SUBJECT: Submits info re mod to load sequencing of ECCS equipment
 result of 850822 loss of transformer concurrence w/LOCA that
 could have defeated load sequencing logic of diesel update.

Subject: Duane Arnold Energy Center
Docket No: 50-331
Op. License No: DPR-49
Load Sequencing of ECCS Equipment
Reference: LER 85-36
File: A-118b

TITLE (4) **Emergency Diesel Generators Sequencing Design Anomaly**

SCHEME 2R201

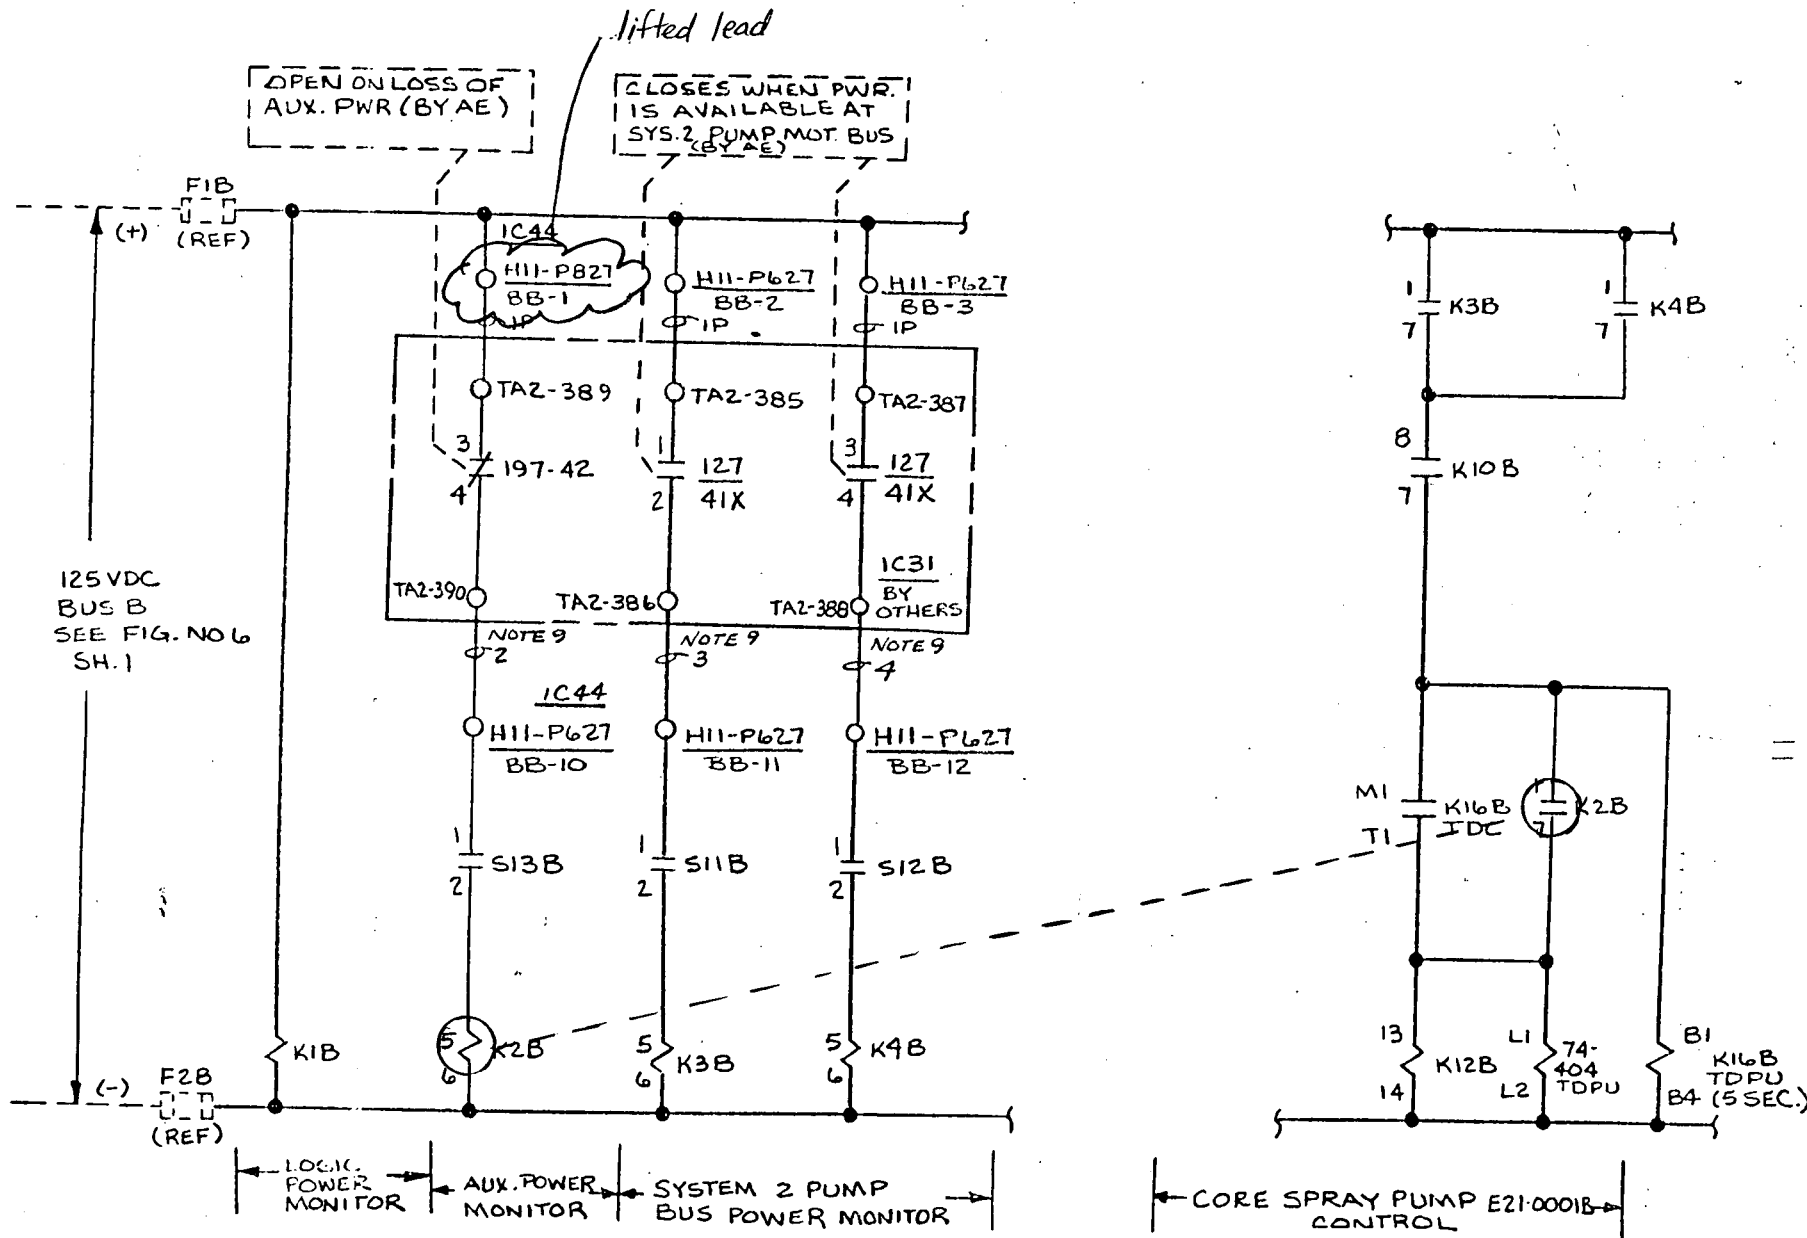
degraded bus voltage condition occurs. Therefore, if the essential loads were powered by the standby transformer and a LOCA occurred at the same time as the standby transformer failed, the output voltage of the startup transformer would have prevented the LOOP detection logic from sending a LOOP signal to the pump start circuitry. This would have caused all CS and RHR pumps to load to their respective diesel generators simultaneously.

A design change was made to correct the problem described above permanently. The automatic CS and RHR pump start circuitry was modified so that the pumps sequence on at all times following a LOCA signal regardless of the status of offsite power. The design change disconnected one wire leading to each K-2A (Division I) and K-2B (Division II) relay coil, thereby preventing actuation of the K-2A and K-2B relays under any condition (see Attachment 1, left side). Disconnecting these relays bypasses the automatic instantaneous start feature (K-2A/B relay contacts remain open) on the pumps and directs the LOCA pump start signal to the appropriate time delay pickup (TDPU) relay (Attachment 1, right side). As a result, the pumps will sequence onto their respective buses.

DAEC Electrical System
Figure 8.2-6

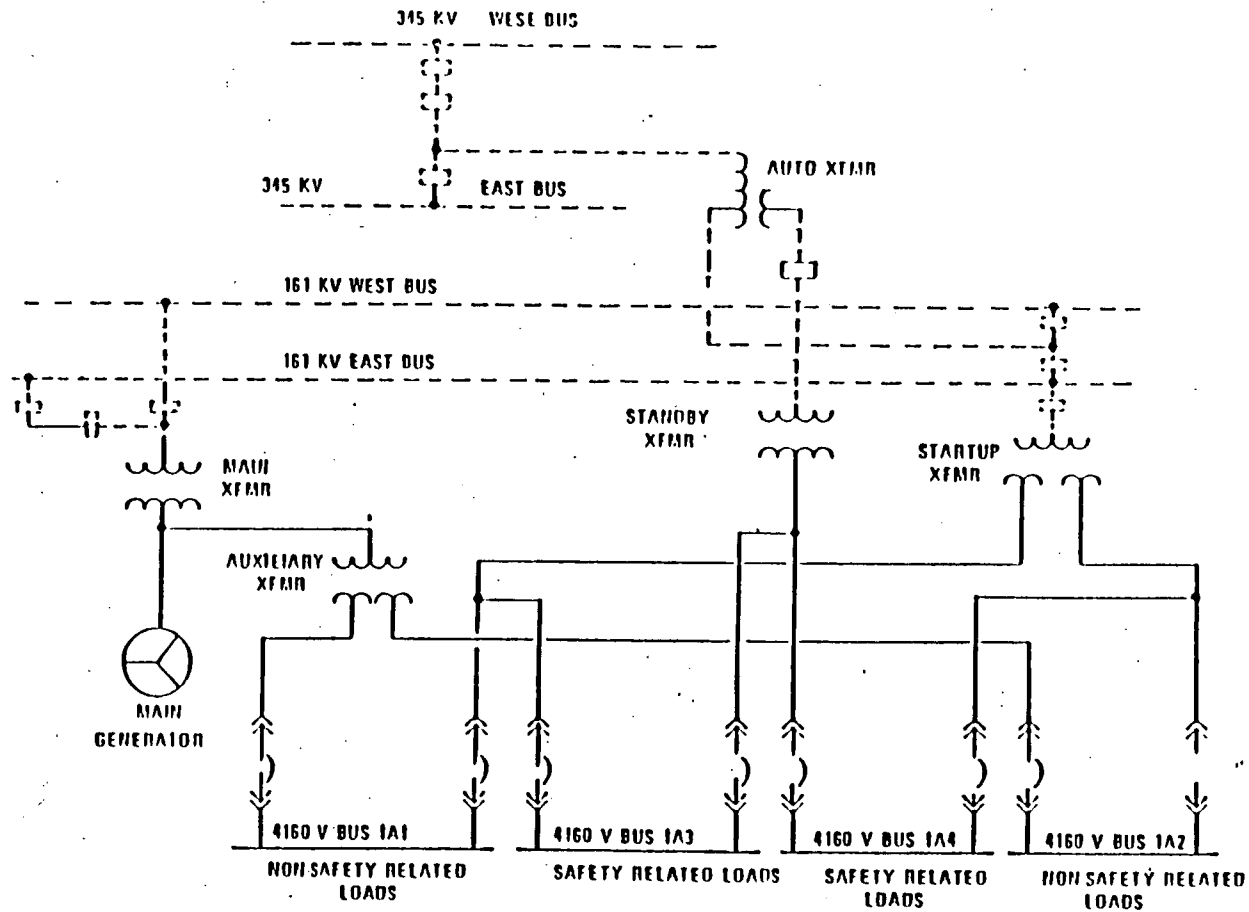
The Duane Arnold Energy Center has four 4160 V buses, two vital and two non-vital. (See attached drawing identified as Figure 8.2-6.) The normal plant lineup when in power operation has the two vital buses powered off the Startup Transformer (which is connected to offsite power) and the two non-vital buses powered from the Auxiliary Transformer (which is fed from the plant's main generator). A third transformer, the Standby, which can only supply the two vital buses remains idle. Should the Startup Transformer fail, the vital buses are automatically transferred to the Standby Transformer and the EDGs start. Should the Standby Transformer also fail to provide power to the vital buses, the EDGs will load.
